Project Name: Home 2 by Hilton

**CITY OF BEAUFORT
DESIGN REVIEW BOARD
Staff Report
Meeting of February 11, 2016**

Case Number: 16-02 DRB.1
Project: Home2 by Hilton
Property Address: Parris Island Gateway & County Shed Road
Parcel #: R120 026 000 0160 0000 (a portion of this parcel)
Zoning: Highway Commercial
Design District: US 21 Design District
Type of Review: **Preliminary Review – New Construction**

TREE & TOPOGRAPHIC SURVEY
SHOWING
R120-026-000-0160-0000
LOCATED IN
THE CITY BEAUFORT, SOUTH CAROLINA
PREPARED FOR
DJ DESAI
DATED: 1/21/2016
SCALE: 1" = 40'

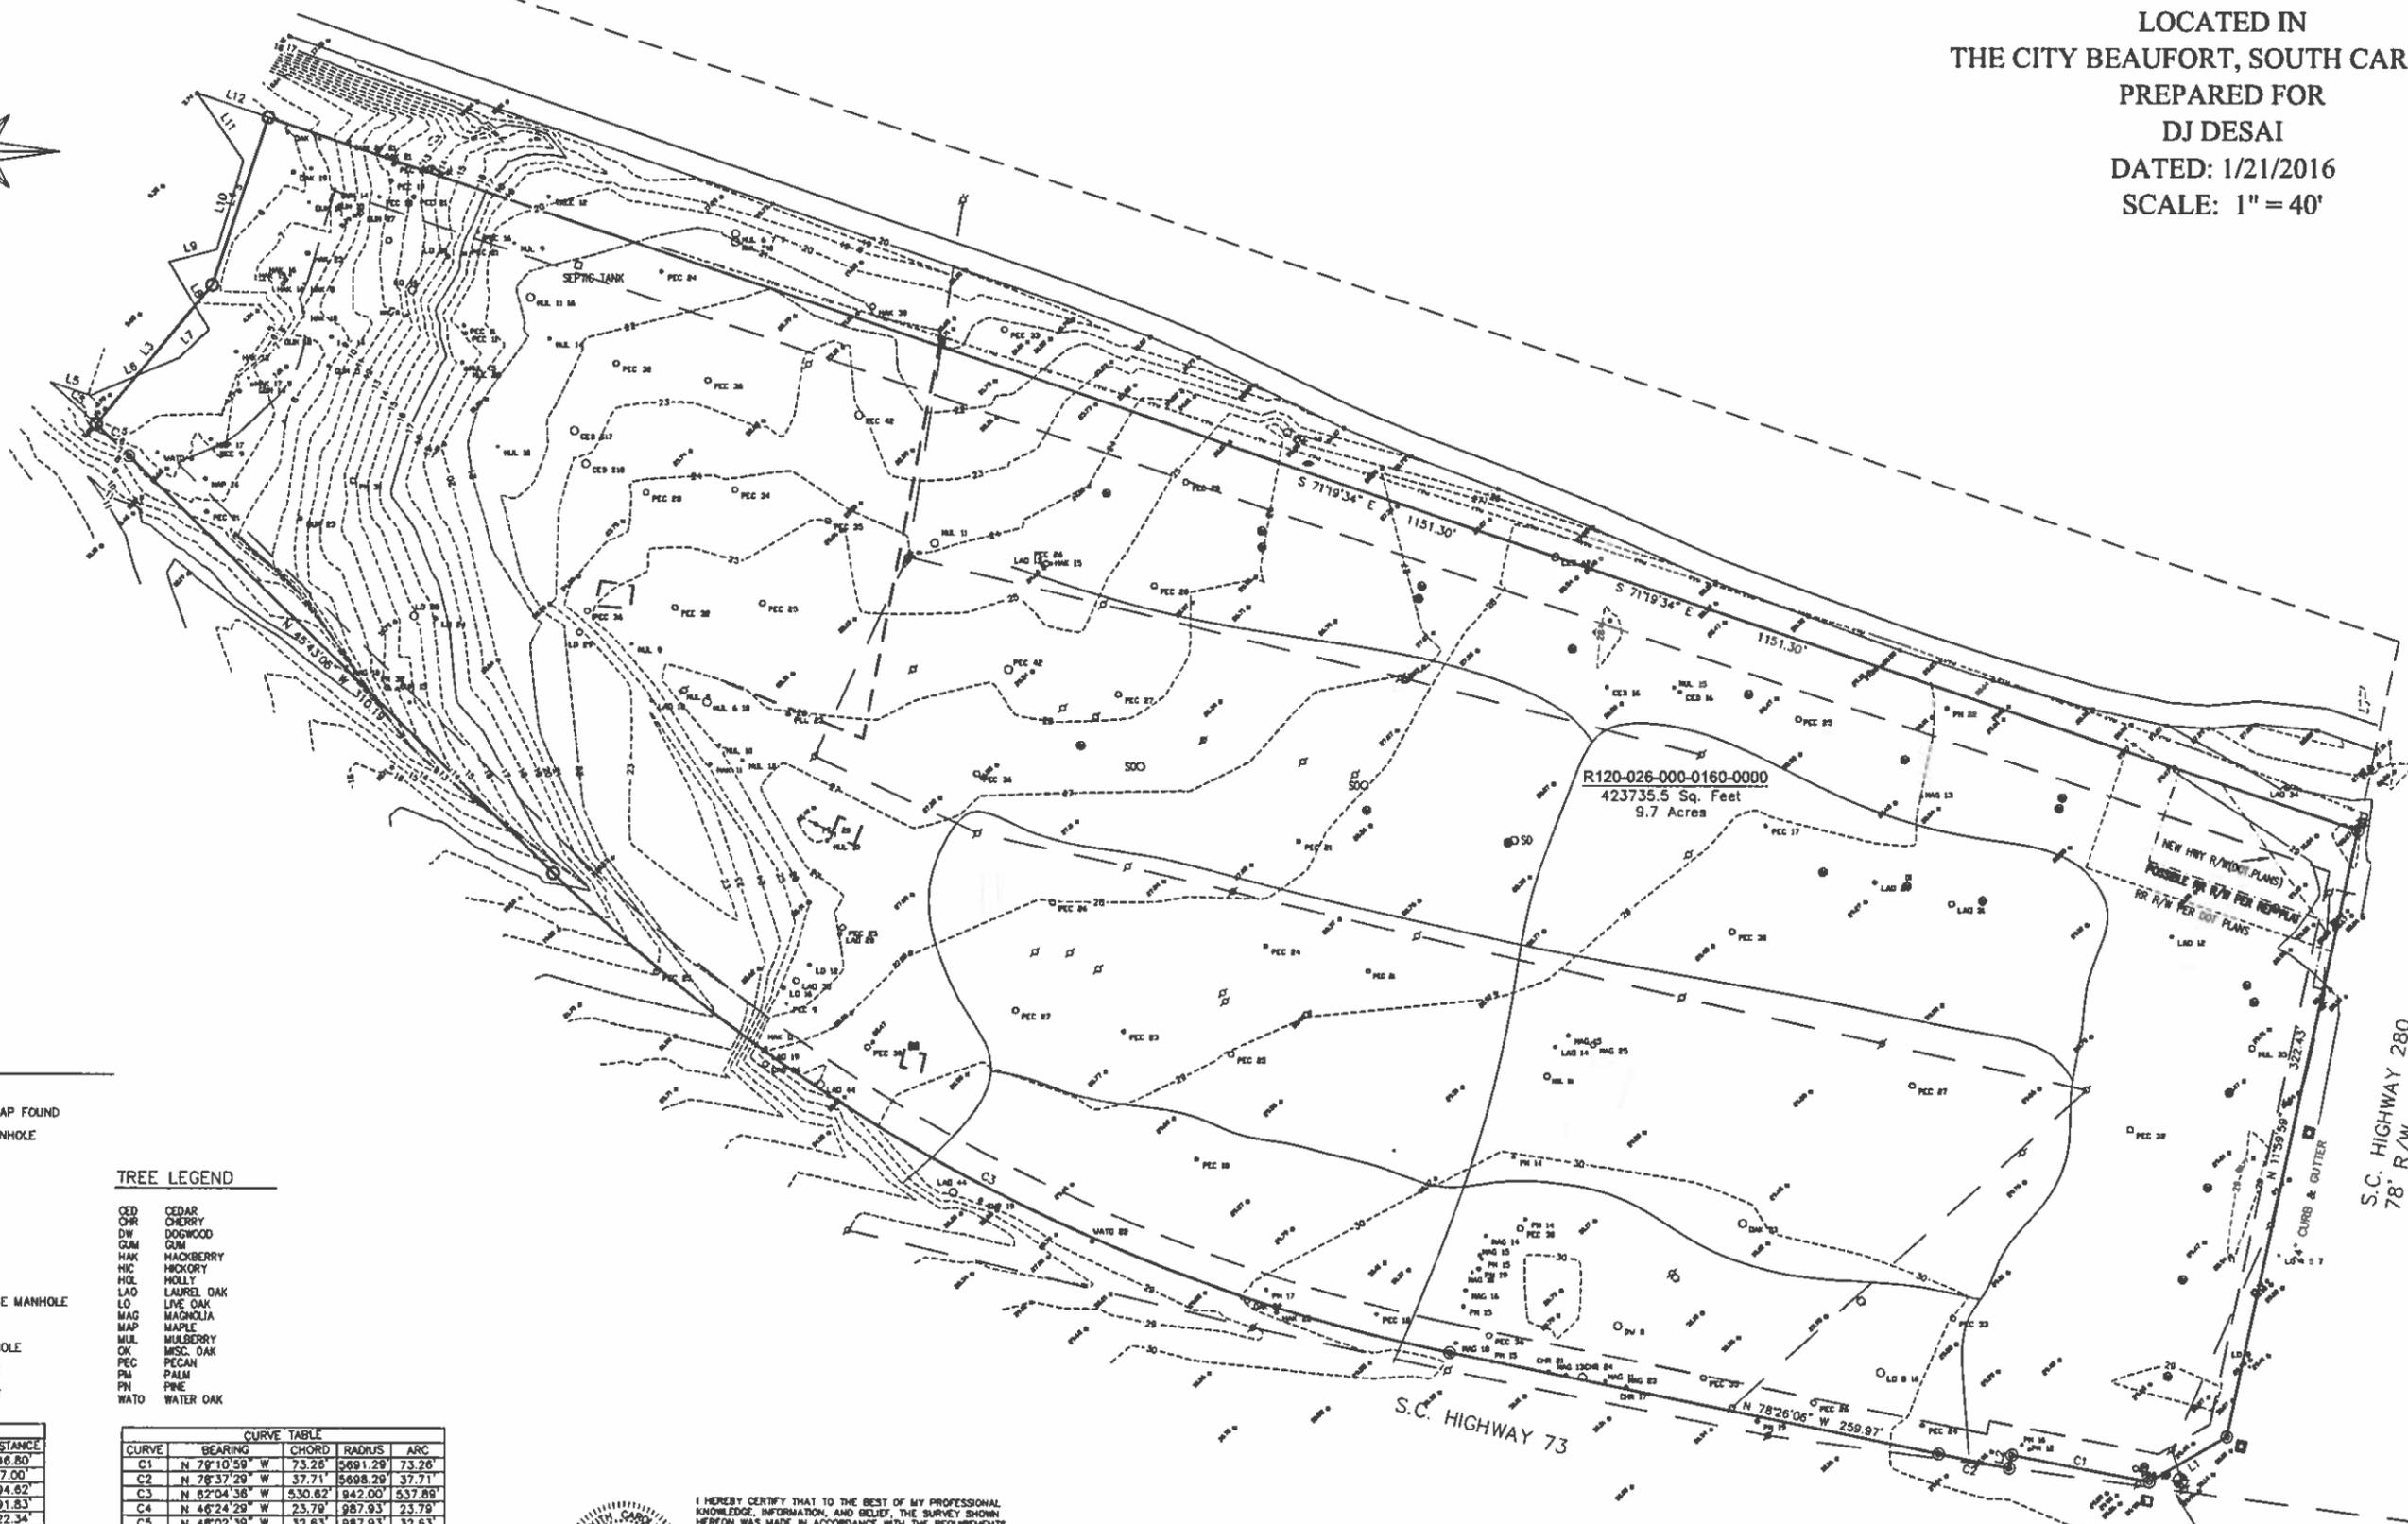
- **Trees:**
 - A tree survey is required. For any Grand Trees 24" caliper or greater, a certified arborist report is required for trees to be removed or retained and impacted by construction.

Sheet No.
A501

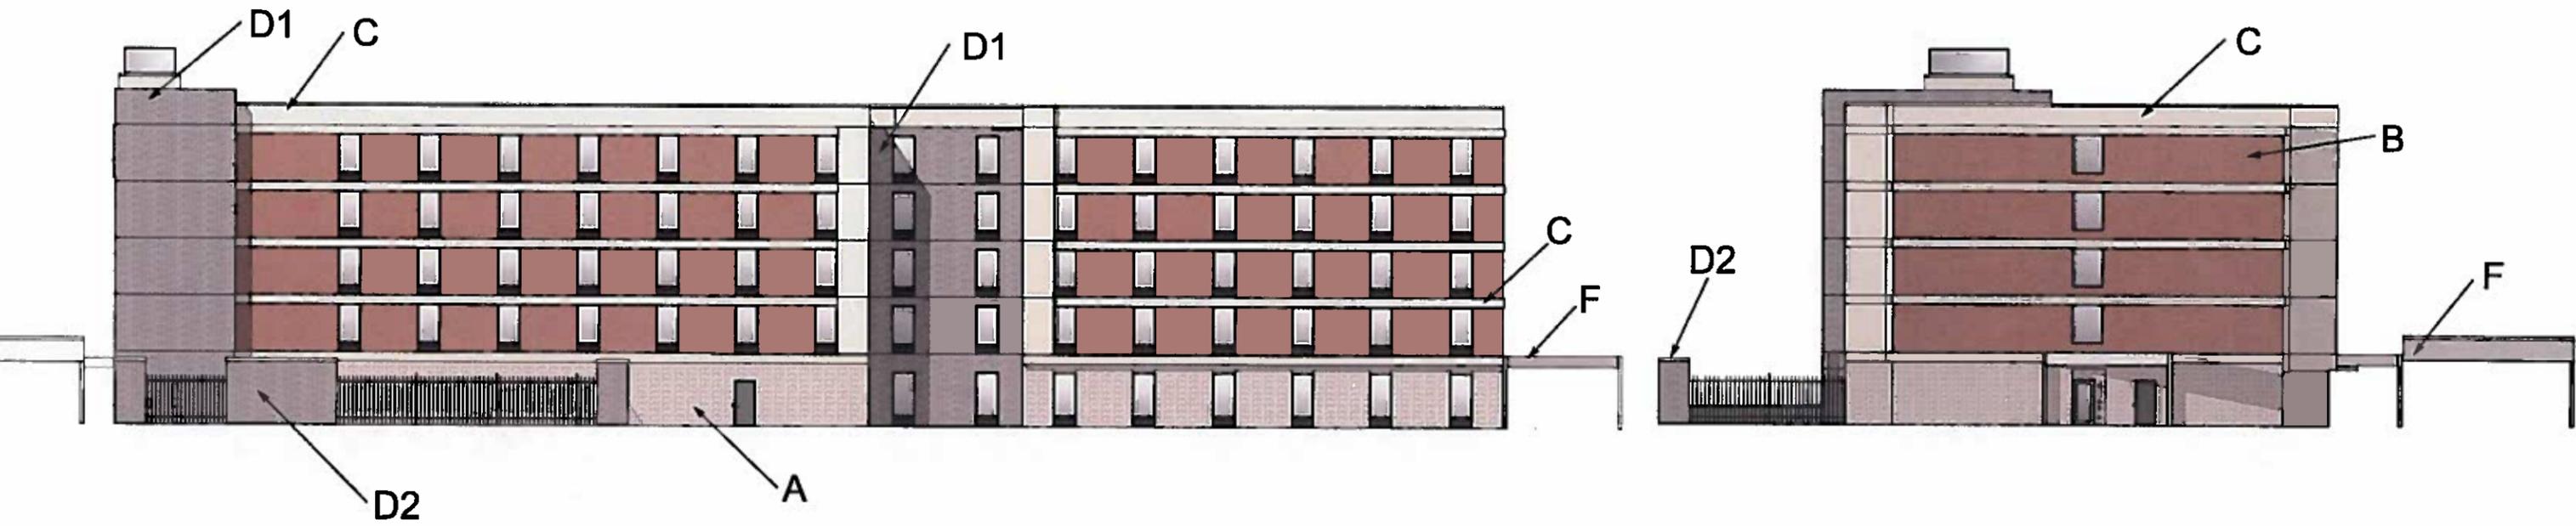
- Along County Shed road (called Ice House road in the submission), this elevation is unarticulated. Since it faces a street, it should have more articulation per the design standards. The South Elevation – Option shown on A502 is better; is it possible to make any of those actual windows? These are guestrooms, so that does appear to be possible.

- **Materials and Details:**
 - The color and material palette seems appropriate.
 - Regarding the rhythm of the windows, consider using a more regular rhythm. Compare the right-most stucco area on the East elevation with the left-most stucco area on the west elevation. The east elevation has 4 windows centered in that space. The west elevation has the windows jammed against one side, with a large gap on the other side. Elements like this, though it's a modern building, should be rationalized and thought through.
